LAKE MICHIGAN DIVERSION

Findings of the Fifth Technical Committee for Review of Diversion Flow Measurements and Accounting Procedures

**United States Army Corps of Engineers
Chicago District**

July 2004

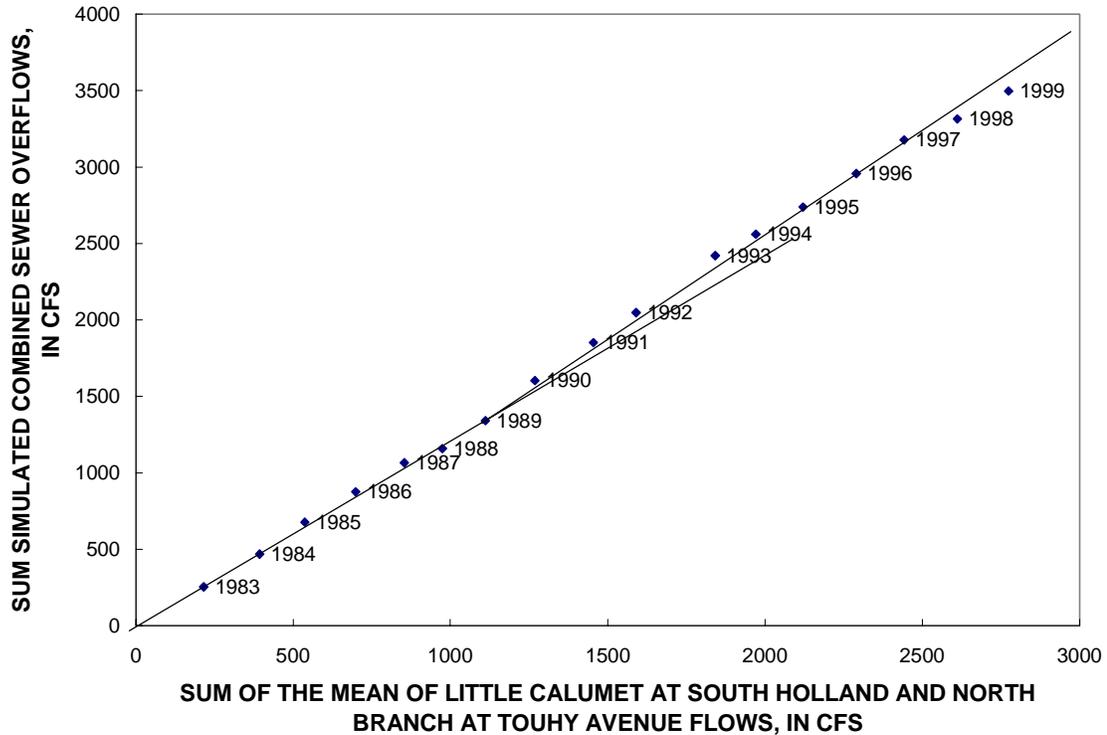
The low value for the Calumet WRP for 1983-1989 resulted because of errors in the simulation of Calumet drainage area and in the per capita sanitary loading that were corrected for the WY 1989 diversion accounting (U.S. Army Corps of Engineers, 1994).

Figure 4.4-a: Comparison of annual mean flow for the unaged, separately sewered lower Des Plaines River watershed and Summit Conduit simulated with the Hydrological Simulation Program – Fortran and estimated by area ratio with Midlothian and Tinley Creeks.

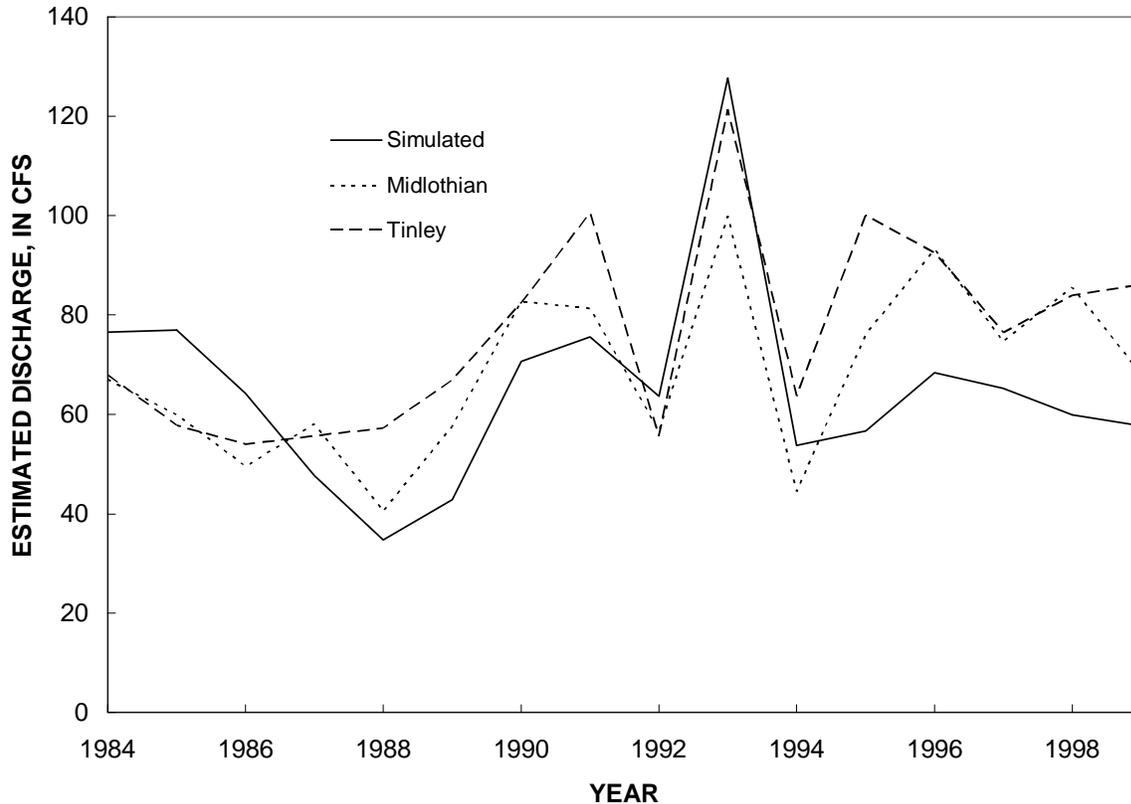
Figure 4.4-a shows the simulated annual flows for the lower Des Plaines River and Summit Conduit watersheds and the annual flows estimated for these watersheds by drainage area ratio with Tinley and Midlothian Creeks. For more than 60 percent of the years the simulated annual flow is less than the estimated annual flow, and the under-predictions typically are in the range of 20-40 percent. Thus, the Des Plaines River watershed flows may be underestimated by the current H&H models. This conclusion is supported by the comparisons of simulated and measured annual flows at the Upper Des Plaines Pump Station for WYs 1984-1994 for which the annual S/R ratios are listed in Table 4.4-a.

The comparison at the Upper Des Plaines Pump Station has many potential errors:

Figure 4.5-a: Double mass analysis of annual mean flow for the Little Calumet River at South Holland versus the average total annual rainfall for the Midway Airport and University of Chicago precipitation gages for Water Years 1951-1994. Trend lines show relation for 1951-1972 and for 1973-1994.

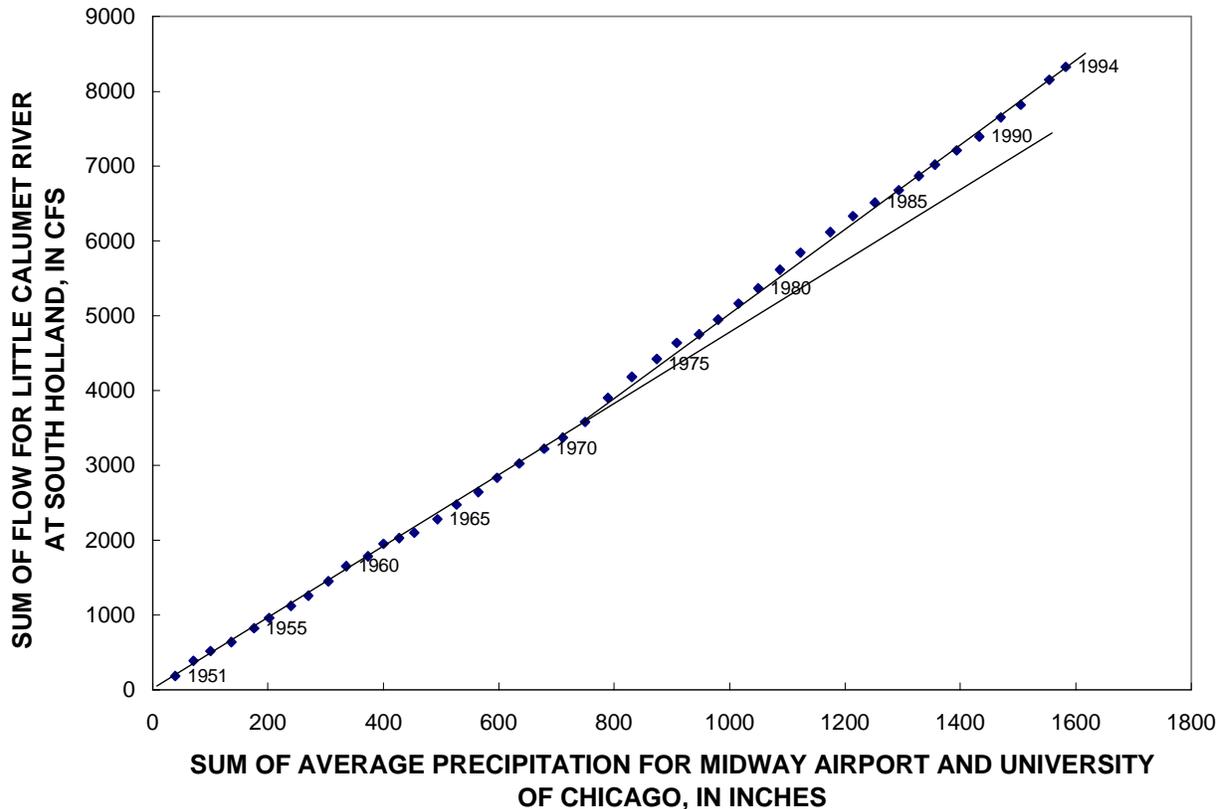
The streamflow separation should be revised as follows to more correctly adjust earlier runoff for 1990 land use conditions. Riggins and Yen (1995) proposed using double mass analysis of annual mean flow from an urbanizing watershed against reference precipitation stations or runoff from nearby rural watersheds to detect the effect of urbanization on runoff. Riggins and Yen (1995) presented several examples from the Des Plaines River watershed to illustrate the concept. Figure 4.5-a shows a double mass analysis of the sum of the annual mean flow from the Little Calumet River at South Holland versus the sum of the average of the annual total precipitation at the Midway Airport and University of Chicago gages for the WYs 1951-1994. Figure 4.5-a indicates that the flow substantially increases relative to rainfall after 1972. If the measured annual mean flow from 1951-1972 were to be consistent with that for 1973-1994, it would have to increase by 19 percent. This large increase may result in part due to an increase in wastewater flow, which also results from urbanization, and does not constitute a runoff adjustment factor for this watershed. The example presented here is just an illustration of how the double mass curve method could be used. In actual application, the annual runoff after streamflow separation should be summed and plotted versus the sum of representative precipitation. Precipitation in or near the Little Calumet River above South Holland or the North Branch Chicago River above Touhy Avenue watersheds would be better reference precipitation stations for these watersheds than Midway Airport or the University of Chicago. Riggins and Yen (1995) should be consulted for additional ideas on the double mass curve approach to estimating urbanization effects on runoff.
